Subject: Duke Energy Carolinas, LLC.
William States Lee III Nuclear Station - Docket Nos. 52-018 and 52-019
AP1000 Combined License Application for the
William States Lee III Nuclear Station Units 1 and 2
Partial Response to Request for Additional Information
(RAI Nos. 820, 821, 822, 823, 824, and 825)
Ltr# WLG2008.10-14

Lee Nuclear Station Response to Request for Additional Information (RAI)

RAI Letter No. 017

NRC Technical Review Branch: Hydrologic Engineering Branch (RHEB)

RAI Number 02.04.02-002 Figure 1

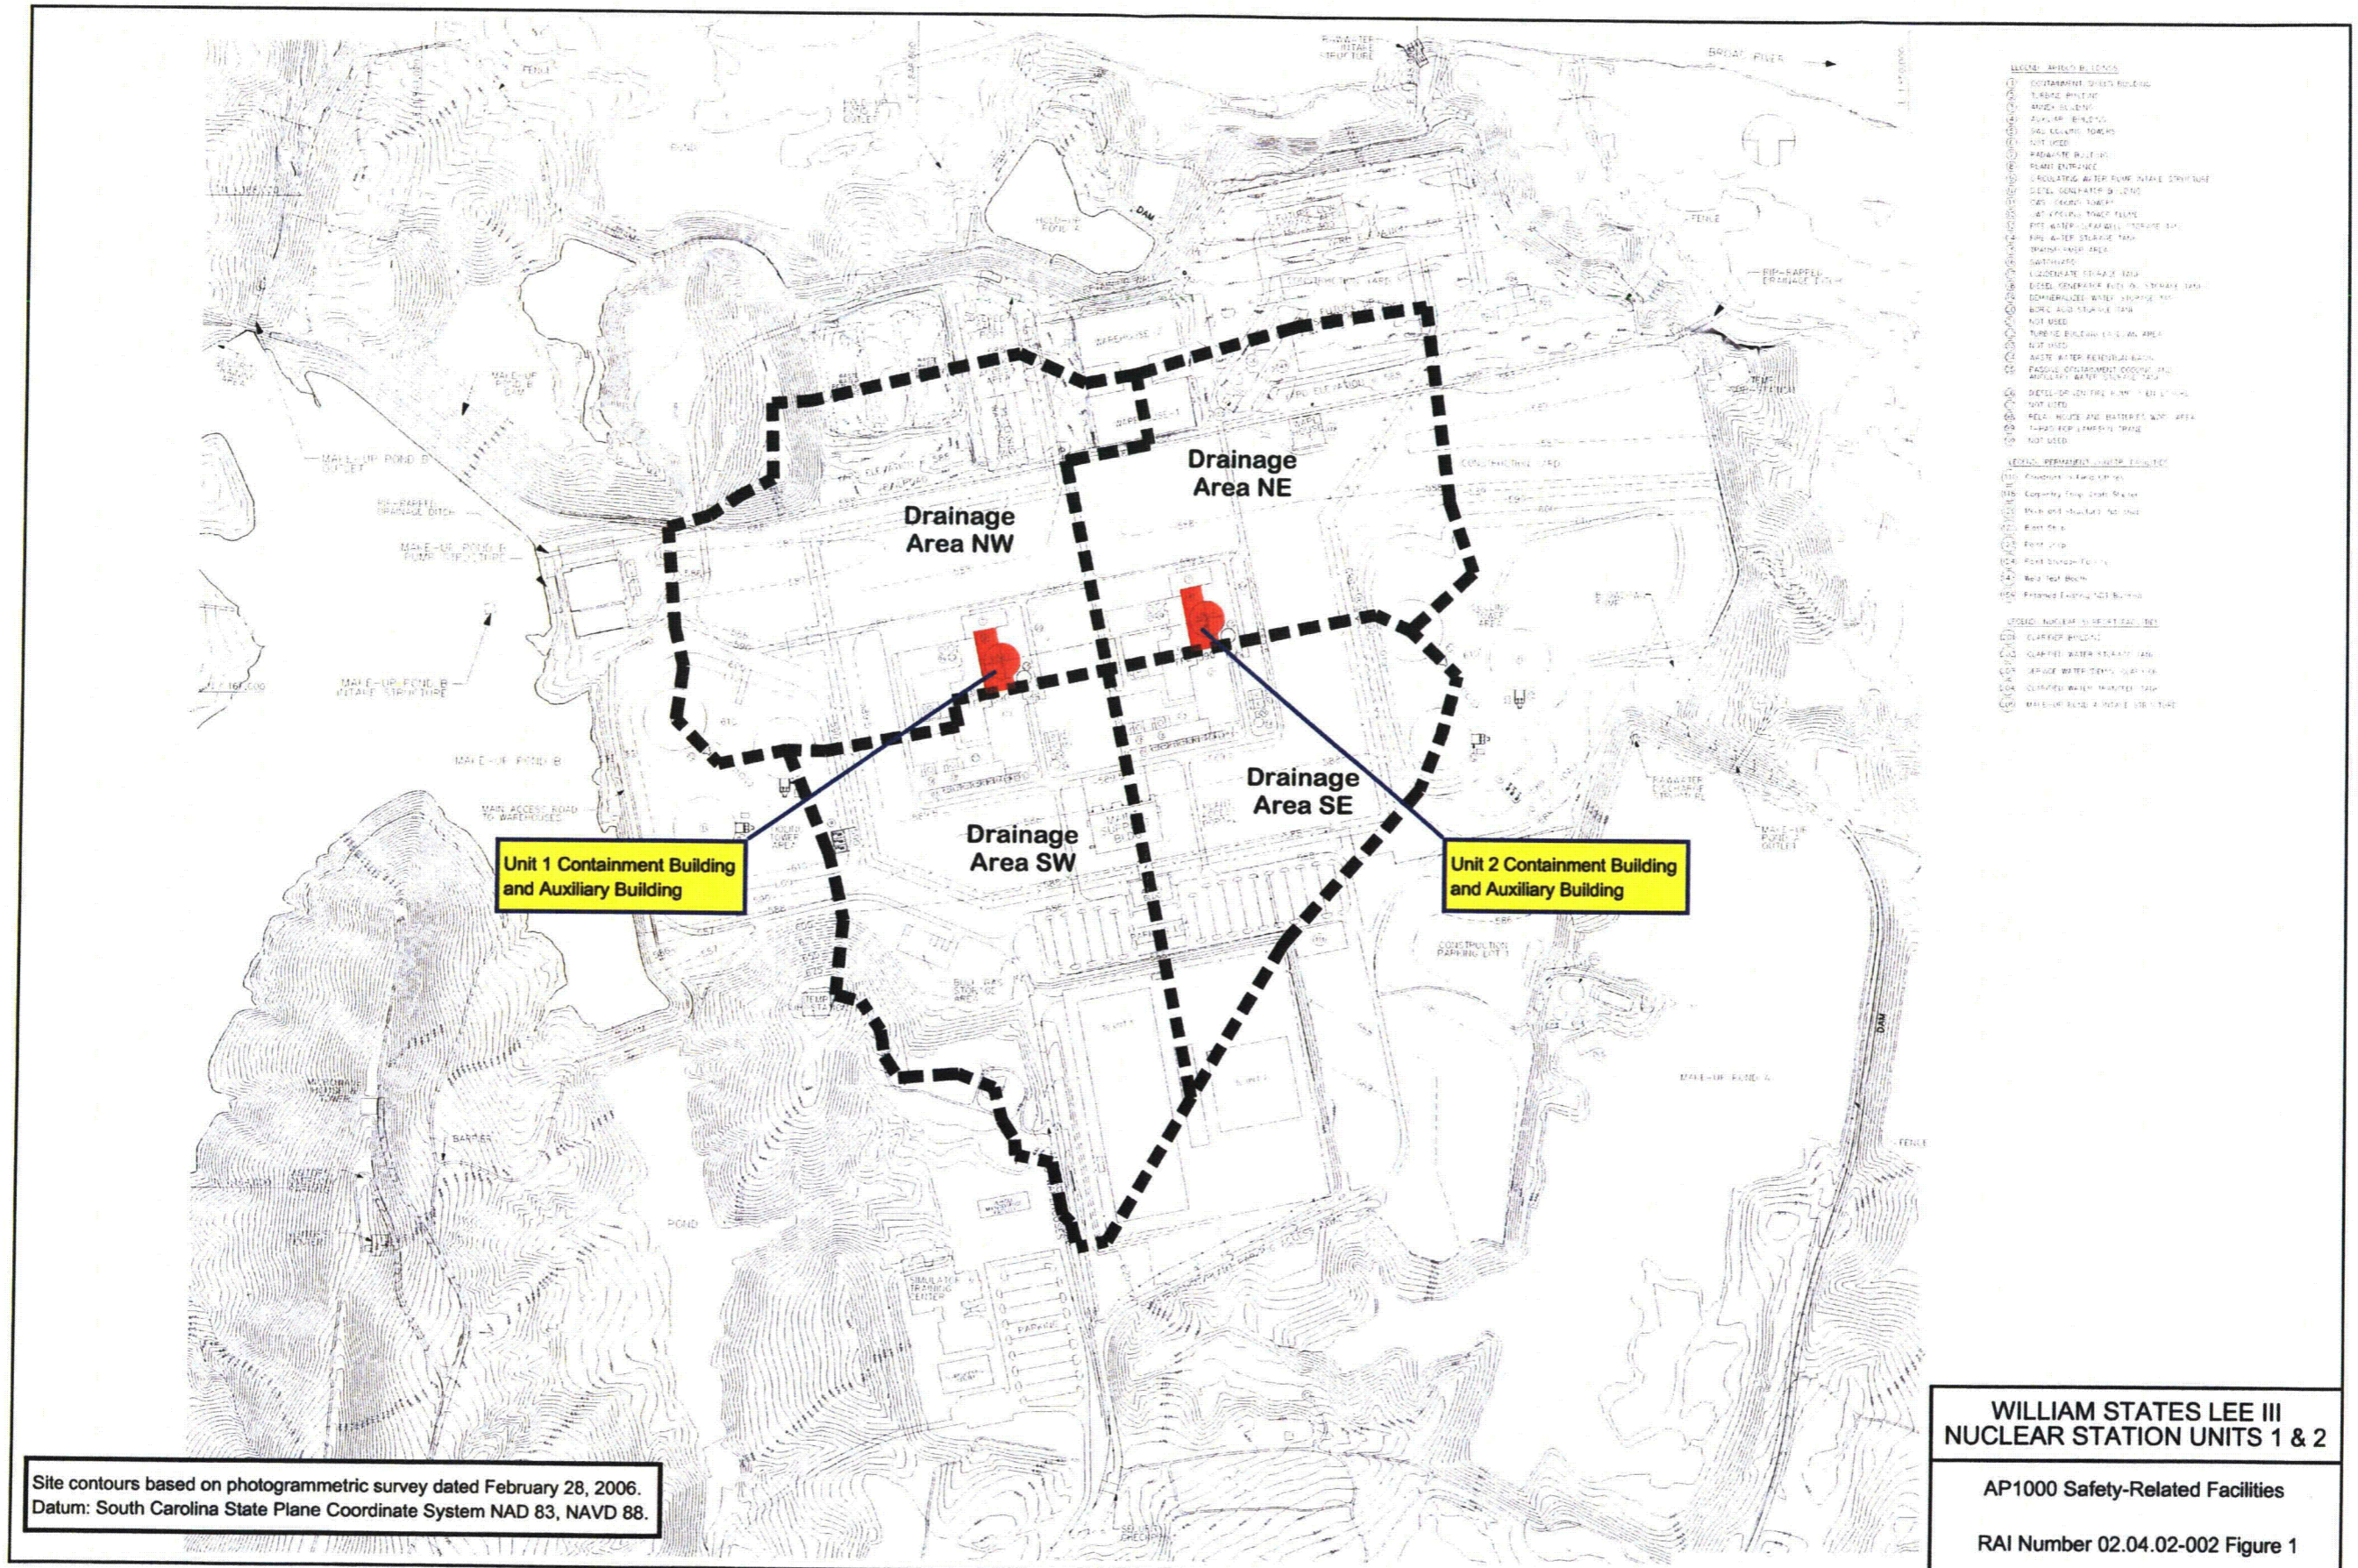
Provide input files used in the HEC-RAS analysis described in FSAR Section 2.4.2.3. Provide details of the iterative process used with the HEC-RAS model to determine water surface elevations during the local intense precipitation event described in FSAR Section 2.4.2.3. In Table 2.4.2-204, how were the times of concentration for the site drainage areas determined? Provide the locations of safety-related structures where the maximum water surface elevations for each of the site drainage areas in Table 2.4.2-204 are presented.

Duke Energy has modified the text of FSAR Subsection 2.4.2.3 to provide a description of the iterative process used to determine the times of concentration in Table 2.4.2-204 for the site drainage areas and resulting water surface elevations during the local intense precipitation event. A revision of FSAR Subsection 2.4.2.3 text is provided as Attachment 2. Attachment 2 will be incorporated into a future revision of the Final Safety Analysis Report.

The resulting water surface elevations at the safety-related structures are identified in Table 2.4.2-204. All Lee Nuclear Station safety-related structures are located above the effects of local intense precipitation at plant elevation 590 ft. For each of the four areas modeled, the table also identifies: the total drainage area, the converged time of concentration for the drainage area, the corresponding PMP depth from the depth duration curve, the converted intensity used in the rational method formula, and the resulting flow rate at the critical cross section.

Shoreline Management Plan Drawing

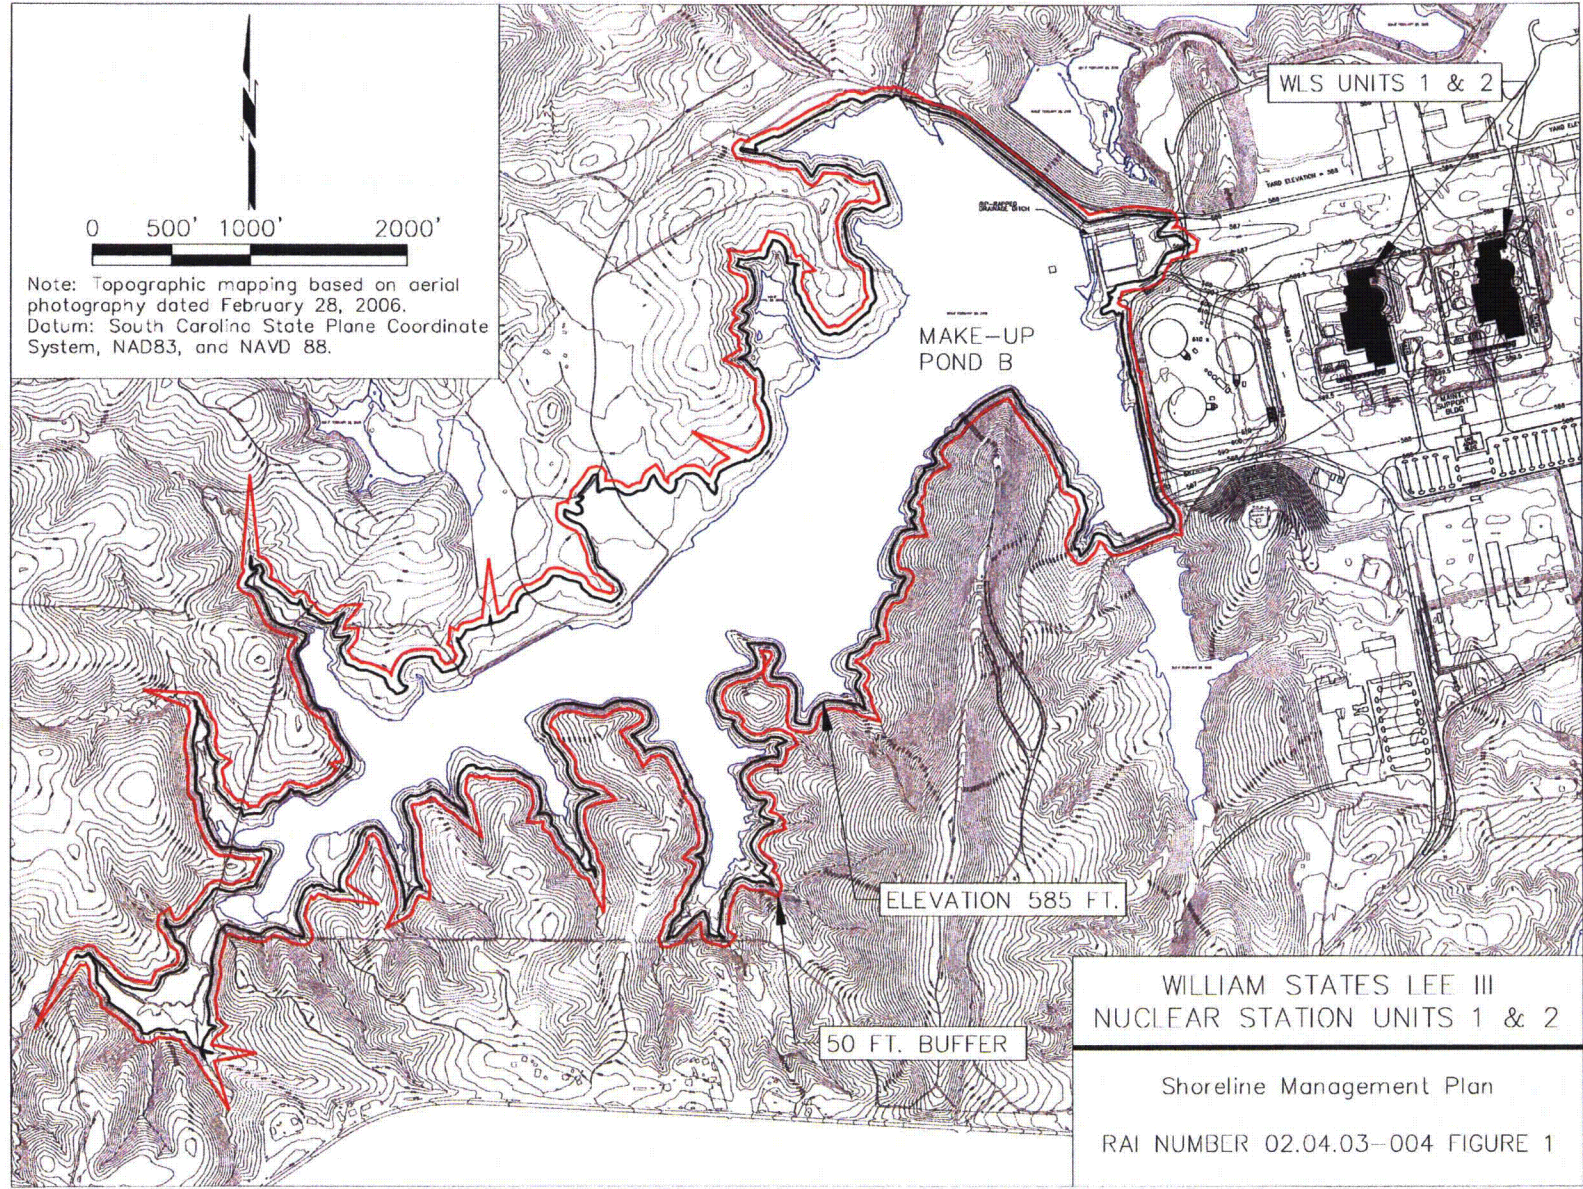
In FSAR Section 2.4.2.2, Flood Design Considerations, and in Table 2.0-201, Comparison of AP1000 DCD Site Parameters and Lee Nuclear Station Units 1 & 2 Site Characteristics, the maximum flood water surface elevation at the site is stated as 583.85 ft MSL. In FSAR Section 2.4.3.5, Water Level Determinations, the maximum water surface elevation corresponding for McKowns Creek/Make-Up Pond B under conservative PMF conditions is stated as 589.40 ft MSL, followed by a discussion of the need to install a debris collection boom near the Make-Up Pond B spillway. Clarify which of the two analyses forms the basis for selection of the design-basis flood water surface elevation at the Lee Nuclear Station site. Why is installation of a debris collection boom considered? If it is required to maintain the flood water surface elevation below the site grade, would the debris collection boom be considered a safety-related structure or system?

Duke Energy has reviewed the elevations for Make-Up Pond B, fed by McKowns Creek, and the limitations presented by the outlet structure. The maximum flood level at the Lee Nuclear Station is elevation 584.3 ft. msl. This elevation would result from a Probable Maximum Flood (PMF) event on the Make-Up Pond B watershed with the added effects of coincident wind wave activity. Details of the coincident wind wave activity are provided in response to RAI Number 02.04.03-005 (this letter). The Lee Nuclear Station safety-related structures have a grade elevation of 590 ft. msl, providing over 5 ft. of freeboard from the worst potential flood considerations.

A shoreline management program is established along the banks of Make-Up Pond B. The shoreline management program consists of removing all the trees from the water's edge at elevation 570 ft. msl to 50 ft. beyond the contour elevation 585 ft. msl around the perimeter of Make-Up Pond B. This area is paved, grassed, or other suitable alternative where appropriate, and is maintained in this manner throughout the operational life of the plant.

FSAR Figure 2.4.3-234

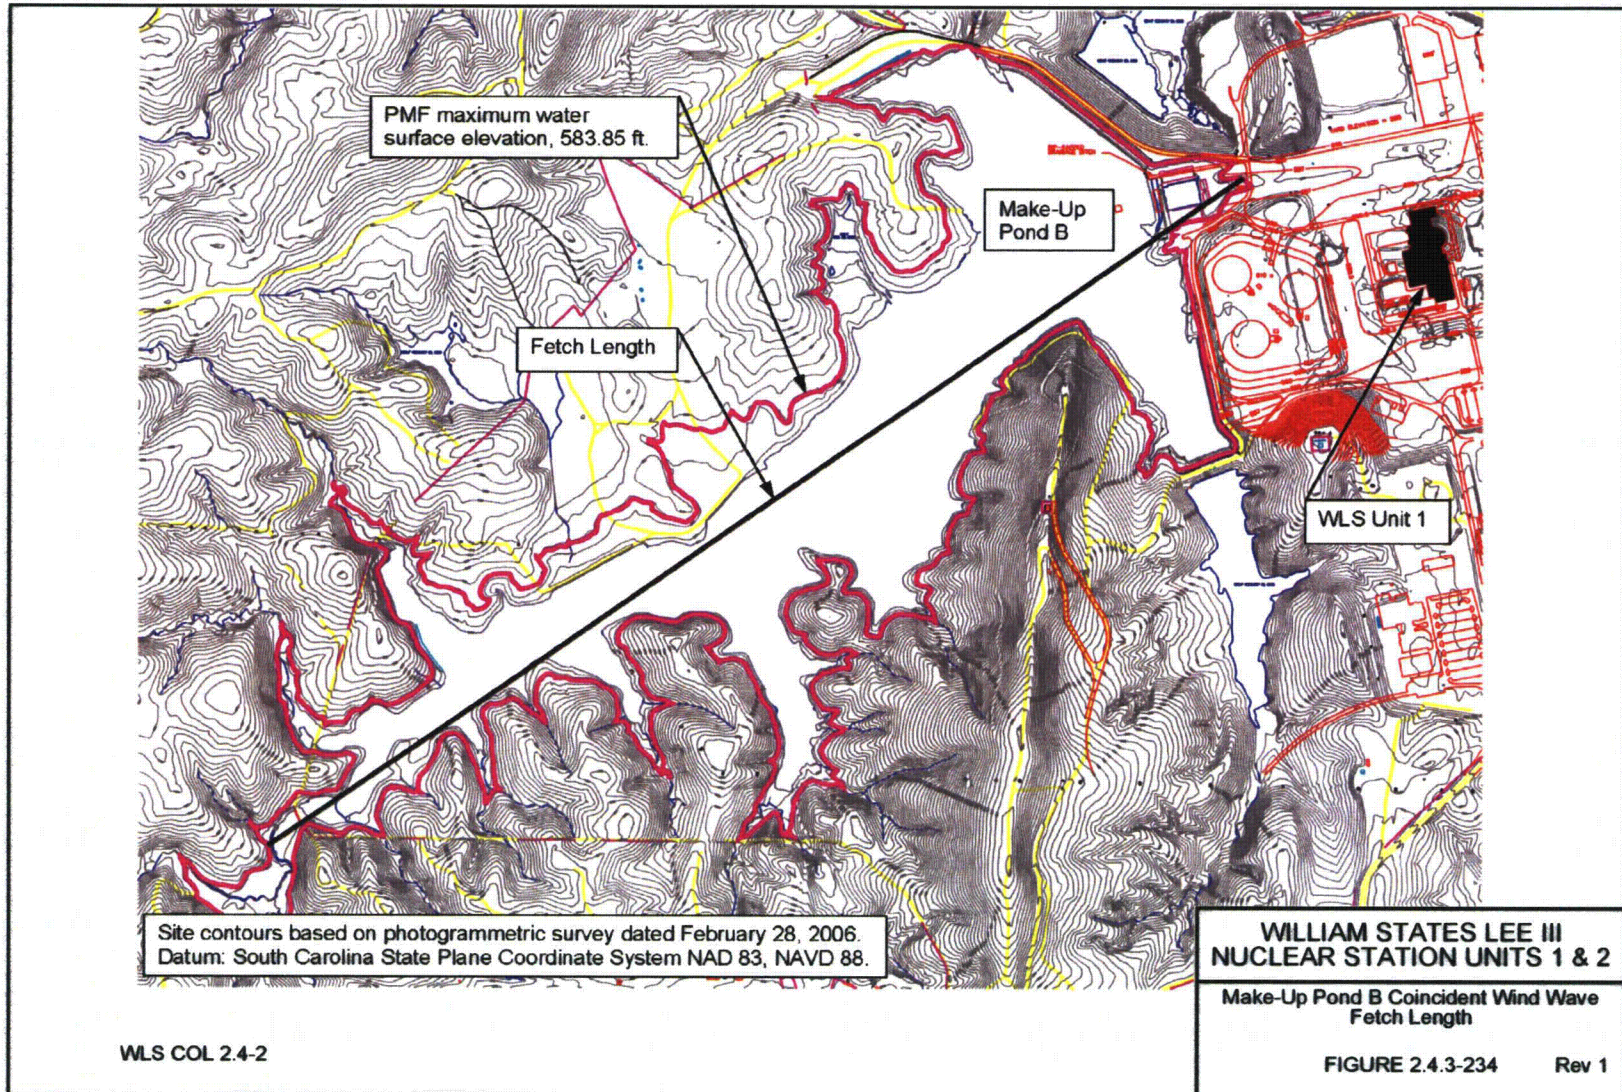
Wind-induced wave heights were not estimated in the determination of the design-basis flood. Provide an update to the design-basis flood analysis that accounts for wind-induced waves. Provide wind-induced wave heights for floods other than the design-basis flood to demonstrate that the selected design-basis flood mechanism is appropriately chosen.

Wind wave activity on Make-Up Pond B is evaluated coincident with the maximum water surface elevation of the PMF as discussed in Subsection 2.4.3.5. The determined critical fetch length of 1.47 mi. is shown in Figure 2.4.3-234. The 2-year annual extreme mile wind speed is adjusted based on the factors of fetch length, level overland or over water, critical duration, and stability. The critical duration is approximately 36 min. The adjusted wind speed is 50.2 mph.

The 0.65 percent slopes along the banks of Make-Up Pond B adjacent to the site are used to determine the wave setup and runup. The maximum runup, including wave setup, is estimated to be 0.30 ft. The maximum wind setup is estimated to be 0.08 ft. Therefore, the total wind wave activity is estimated to be 0.38 ft. The PMF and the coincident wind wave activity results in a flood elevation of 584.3 ft. msl. The Lee Nuclear Station safety-related plant elevation is 590 ft. msl and is unaffected by flood conditions and coincident wind wave activity.
